ITEM: 6.5	REPORT SUMMARY MINOR VARIANCE APPLICATION FILE NUMBER A021/24
------------------	--

**MINOR VARIANCE APPLICATION
FILE NUMBER A021/24
9 ROSSHAVEN CRESCENT WOODBRIDGE**

PROJECT: Proposed Cabana & Pool
 ON
 9 Rosshaven Crescent
 Vaughan

A1.0 Site Plan
 1:150

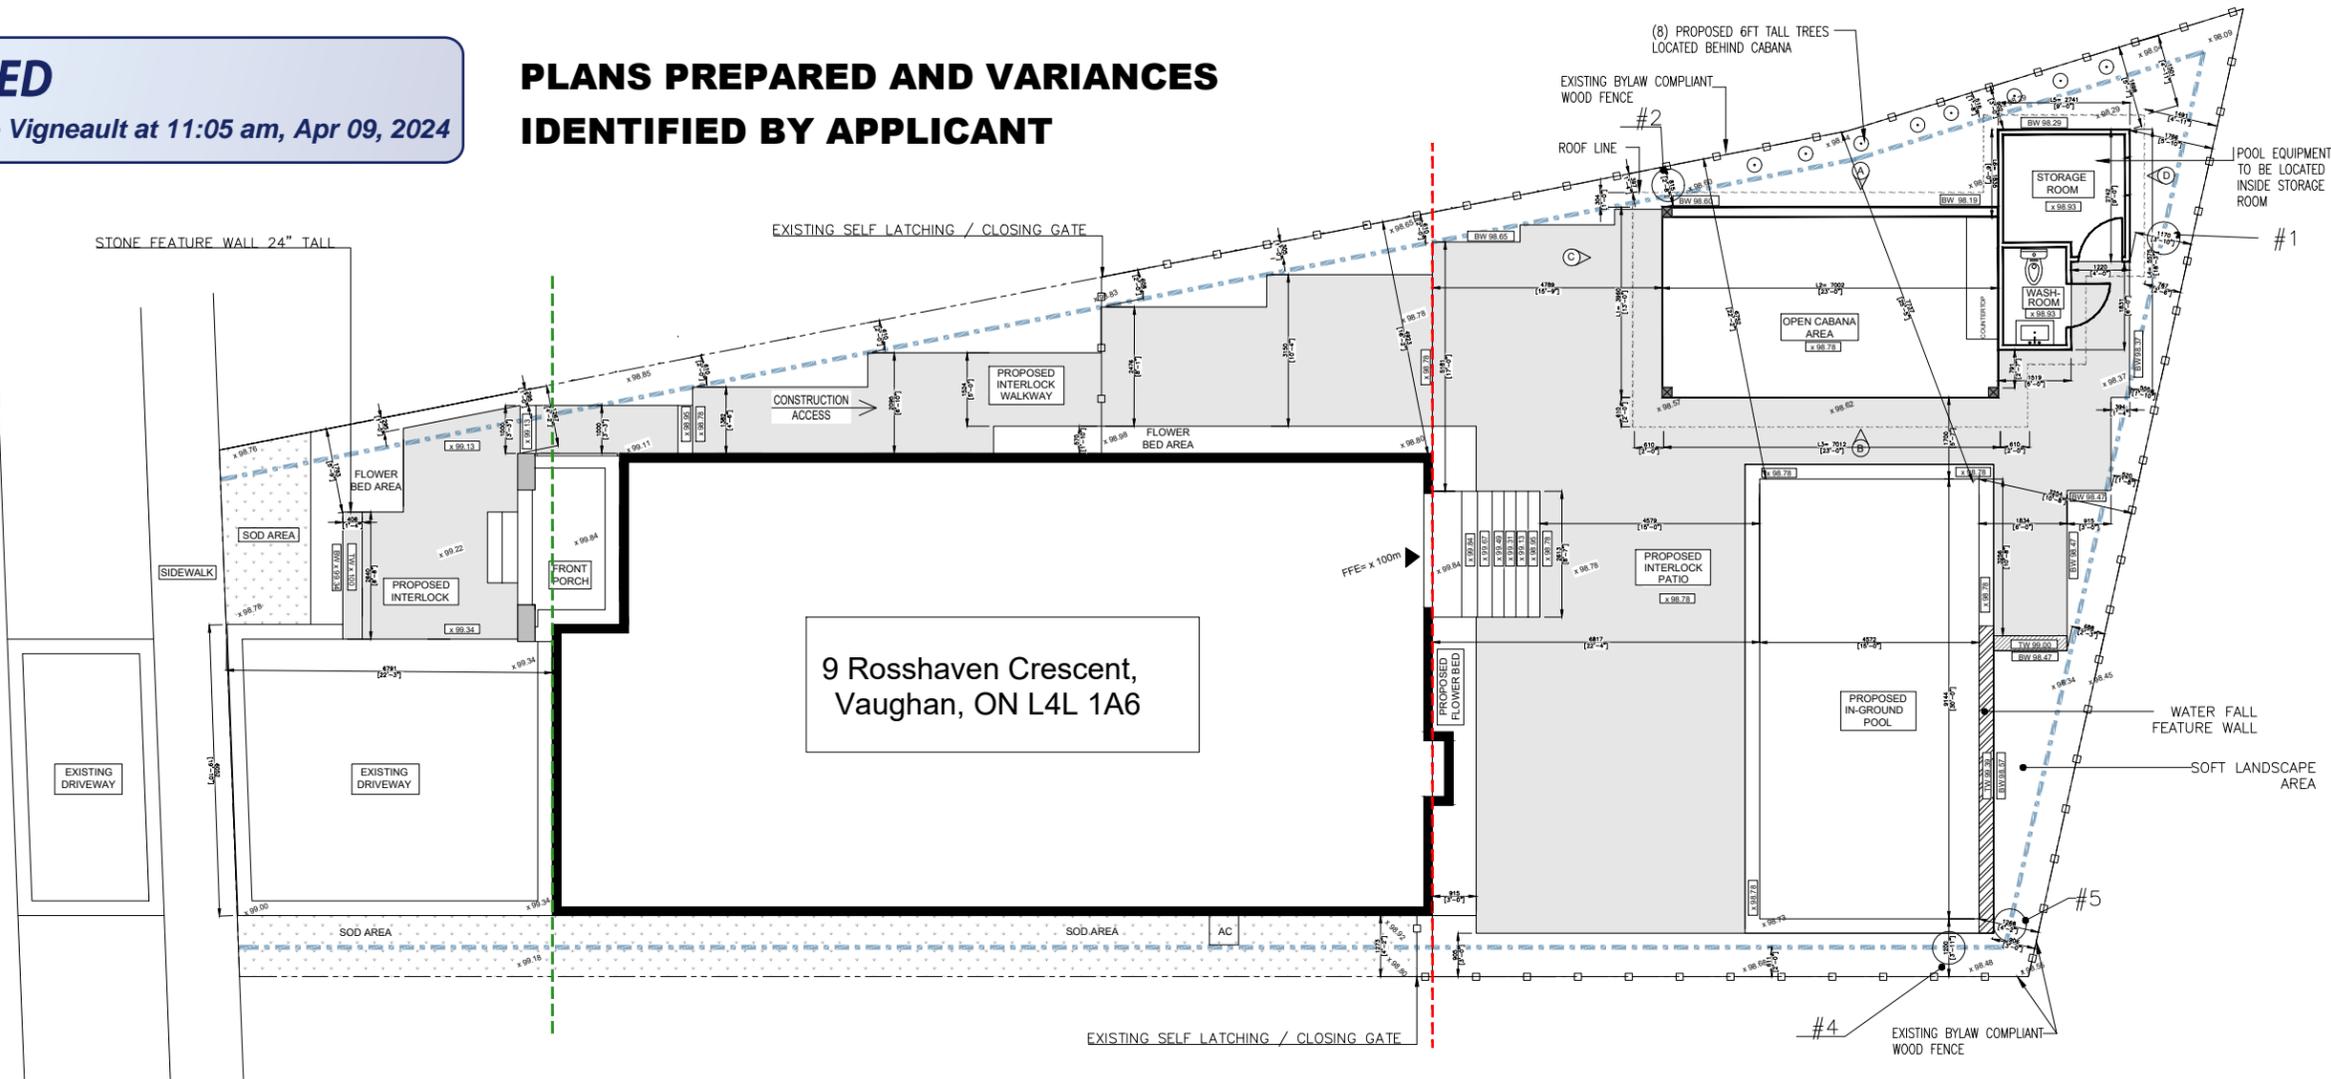
Development Planning Department Staff ('Development Planning Staff') have no objection to Variances 1 and 2 for the proposed cabana. Variance 1 is to permit a minimum rear yard setback of 1.17 metres which is measured at a pinch-point from the southwest corner of the storage room portion of the proposed cabana, increasing to approximately 1.72 metres at the southeast corner of the storage room. The rear lot line setback expands to approximately 3.25 metres at the open portion of the cabana at its greatest extent. The reduction to the minimum interior side yard setback (Variance 2) is sought to address to pinch-points. The first, full 0.38 m reduction is measured at a pinch-point from the northeast corner of the proposed open cabana area. The second pinch-point, a 0.29 m reduction, is measured from the northeast corner of the storage room.

The setback increases above compliance to approximately 2.45 metres where the open and storage room portions of the cabana meet. The reduced interior side yard setback is not anticipated to pose adverse massing or privacy concerns to the properties to the east (5 Rosshaven Crescent & 169 Purple Creek Road) as vegetative screening is proposed at the request of Development Planning Staff to alleviate such concerns. The Owners propose planting a total of eight (8) 6-foot-tall cedars between the cabana's east wall and the nearby east fence. The cedars will help provide a visual buffer between the accessory building and the two neighbouring rear yards to the east (5 Rosshaven Crescent and 169 Purple Creek Road) to mitigate potential mass and privacy impacts. The rear yard and interior side yard setbacks provide sufficient space for safe access and maintenance. As such, the proposed accessory building is not anticipated to pose adverse massing and/or privacy impacts to the neighbouring properties.

Development Planning Staff have no objection to Variances 4 and 5 for the proposed 0.30 m reduction to the required southerly interior side lot line setback and 0.24 m reduction to the required rear lot line setback for the proposed in-ground swimming pool. The proposed pool would only utilize the full extent of the requested relief for the rear yard setback at its southwest corner, which is a pinch-point, increasing to approximately 3.25 metres at its greatest extent at the pool's southeast corner. The requested interior side yard and rear yard setbacks are not anticipated to be perceptible from a visual perspective and an appropriate area for safe access and maintenance is maintained around the entirety of the pool.

Development Planning Staff have no objection to Variance 6 for the proposed reduction in soft landscaping within the rear yard. At the request of Development Planning Department Staff, improvements were made to reduce the existing hardscaping and provide additional soft landscaping in the rear yard, primarily by proposing planting beds along the rear wall of the existing dwelling. The proposed reduction of 8.4 % from what the Zoning By-law requires (60%) is minimal from a visual perspective, maintains an appropriate balance of soft and hard landscaping within the rear yard, and Development Engineering Staff have also reviewed the application and do not have any concerns regarding drainage. As such, Development Planning Staff are of the opinion that the proposed reduction in rear yard soft landscaping is desirable and appropriate for the development of the land and does not adversely impact the surrounding neighbours or existing character of the existing neighbourhood.

Development Planning Staff have no objection to Variance 7 for the proposed reduction in soft landscaping in the front yard. The proposed 2.53 % (0.99 m²) reduction of landscaped front yard is negligible from a visual perspective and is not anticipated to pose significant adverse impacts on the neighbouring properties nor the existing streetscape and neighbourhood. The proposed reductions are not anticipated to significantly impact the balance of soft landscaping present along the street as a whole. Development Engineering Staff have also reviewed the application and do not have any concerns regarding drainage. As such, Development Planning Staff are of the opinion that the proposed reduction in front yard soft landscaping is desirable and appropriate for the development of the land and does not adversely impact the surrounding neighbours or existing character of the existing neighbourhood.

1
A3
Elevation A
1:50

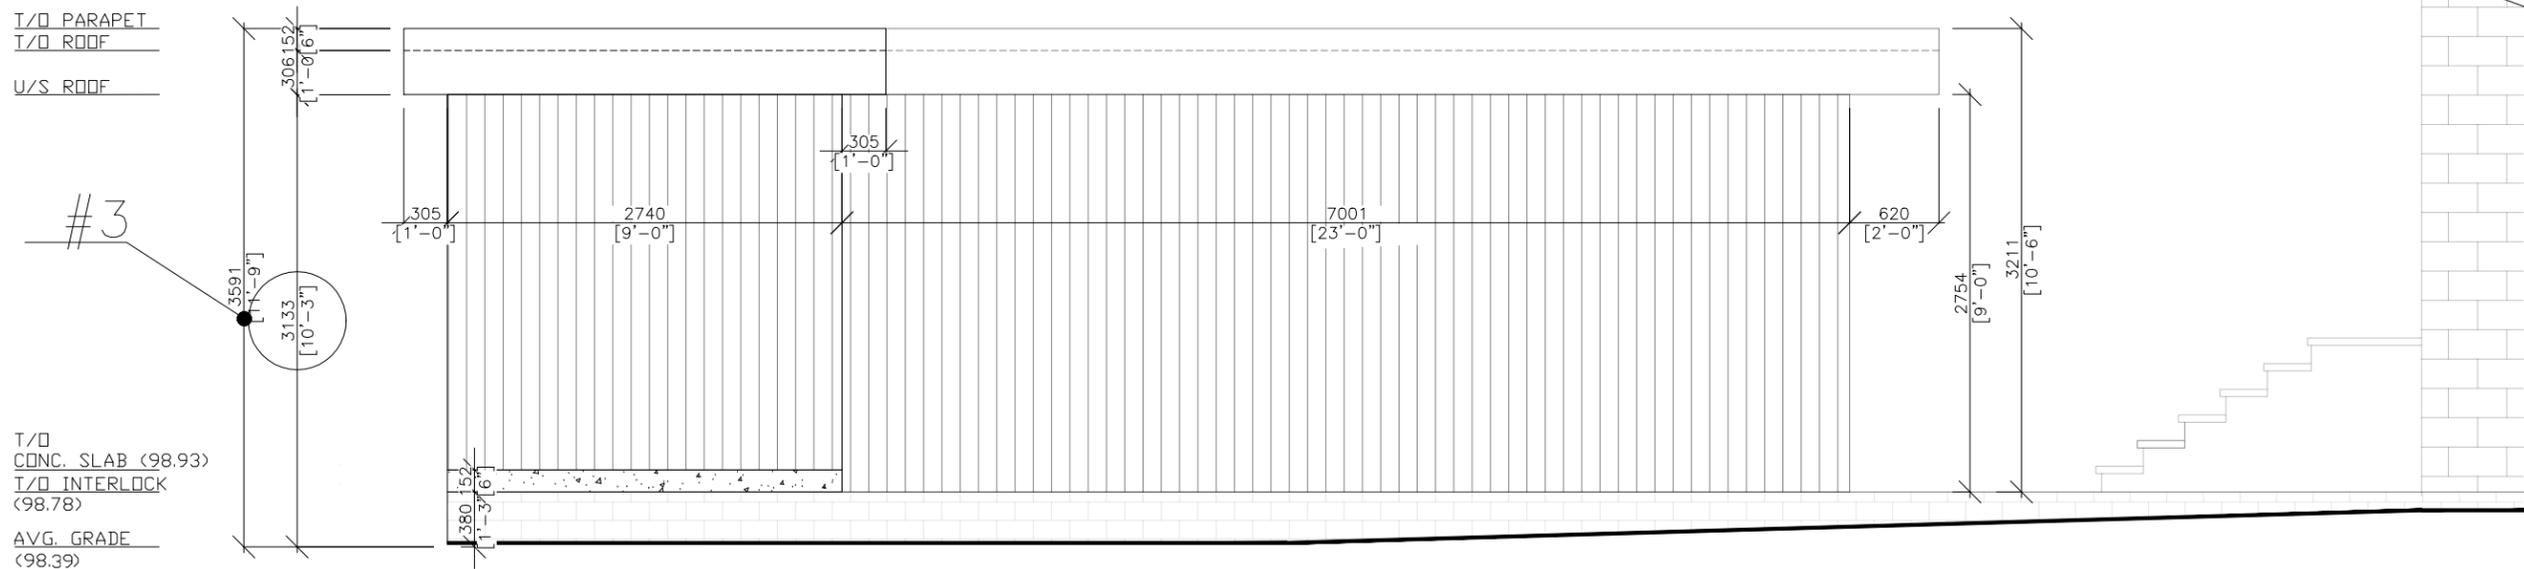
The 0.134 metre increase in maximum building height for an accessory structure (Variance 3) is not proposed to pose any adverse massing or privacy impact on either of the neighbouring properties to the east (5 Rosshaven Crescent & 169 Purple Creek Road) and west (13 Rosshaven Crescent), nor to the properties to the south (34 & 38 Pine Heights Drive). The cabana is relatively long in relation to the side lot line, but its spatial separation from said lot line is not uniform. As noted above, the side yard setbacks are measured to two pinch-points and will be largely buffered/screened by cedar trees to lessen the impacts on the two abutting rear yards to the east the unmitigated height may otherwise generate. As further mentioned above, the minimum rear yard setback is measured at a pinch point and expands to approximately 3.25 metres at its greatest extent. The face of the cabana relative the length of the rear line is also proportionally modest. The modest height increase, when paired with the vegetative buffering and varied setbacks from the lot lines, mitigates the massing concerns resulting with the increased proximity of said taller building to the lot lines.

MINIMUM VERTICAL & HORIZONTAL CLEARANCES OF CONDUCTORS FROM BUILDINGS OR OTHER PERMANENT STRUCTURES (CONDUCTORS NOT ATTACHED TO BUILDINGS)

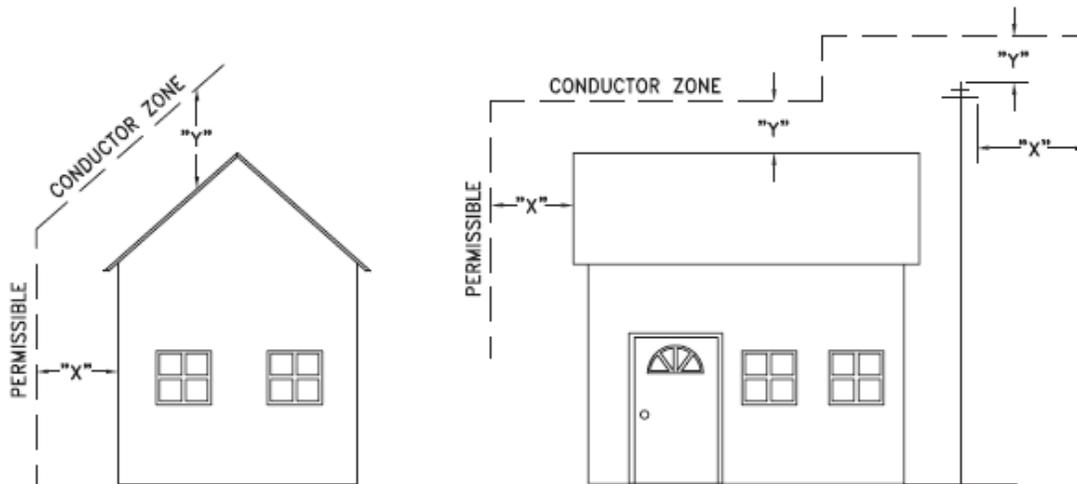
All proposed billboards, signs, and other structures associated with the project or plan must maintain minimum clearances to the existing overhead or underground electrical distribution system as specified by the applicable standards, codes and acts referenced.

In the event that construction commences, and the clearance between any component of the work/structure and the adjacent existing overhead and underground electrical distribution system violates the Occupational Health and Safety Act, the customer will be responsible for 100% of the costs associated with Alectra making the work area safe. All construction work will be required to stop until the safe limits of approach can be established.
